## **Service Bulletin**

**No. :** MZ08-075

**Model:** SR5003, SR6003

**Subject:** INPUT PWB changed to delete soldered wires on the PWB. (The PWB changed for the improvement of product quality.)

**OLD PWB Bottom side**

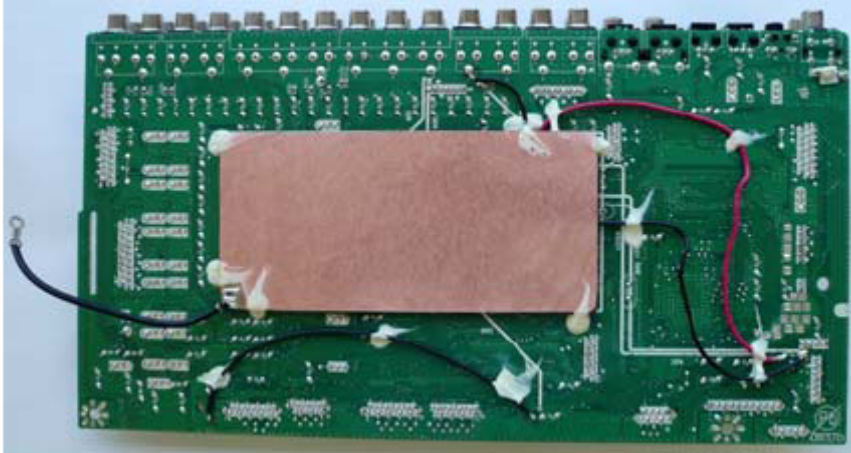
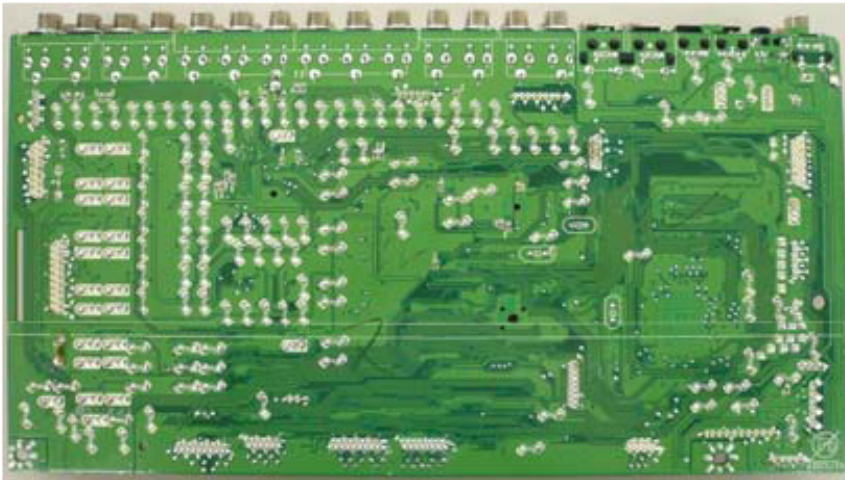
1. INPUT PWB: the layout and pattern changed.
2. INPUT PWB POS.NO. CN83: Changed into a connector from a connector with CORD.
3. Connection Wire: CN83 (FRONT PWB) and BN83 (INPUT PWB) was changed.
4. FRONT PWB POS.NO. CN83 (BN83): Changed into a connector with CORD from a connector.

**Changed**

**NEW PWB Bottom side**

**POS.NO. BN83      943612004690S**

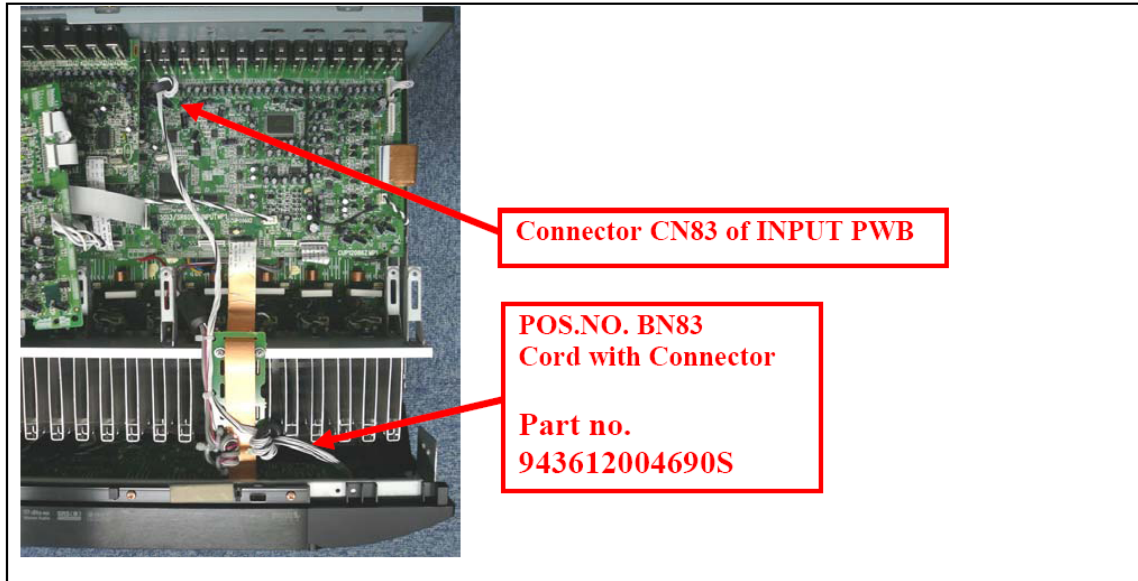
**Caution:** If replacing the INPUT PWB ASSY with a NEW INPUT PWB ASSY,  
The part no 943612004690S is required. NECESSARY PARTS are as follows:

**FRONT PWB POS.NO. CN83 Connector replacement procedure:**

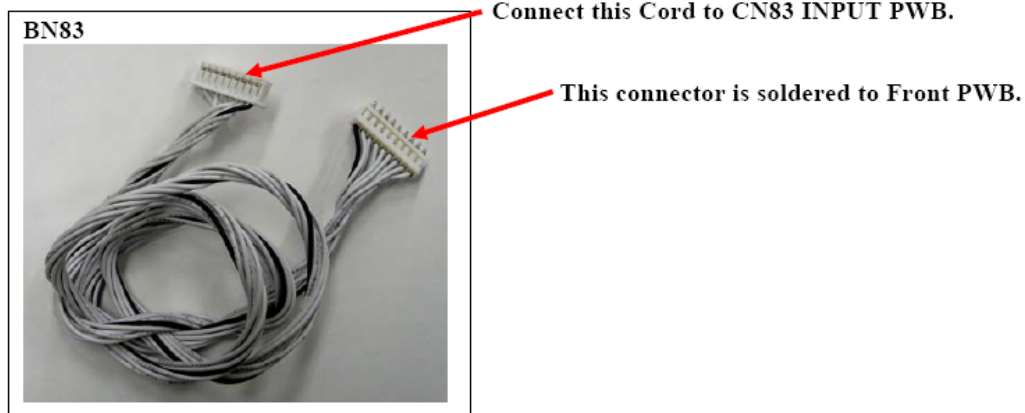
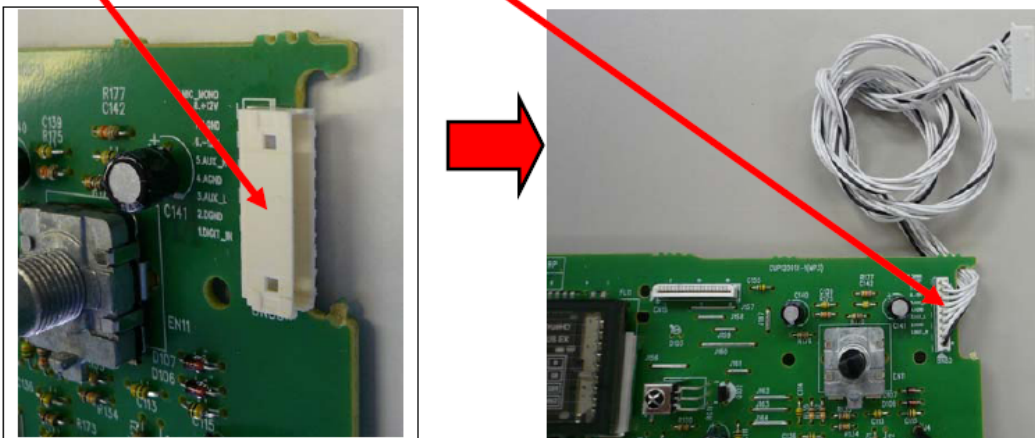
**CN83 (Connector) is removed and BN83 (Cord with Connector) is soldered to Front PWB.**
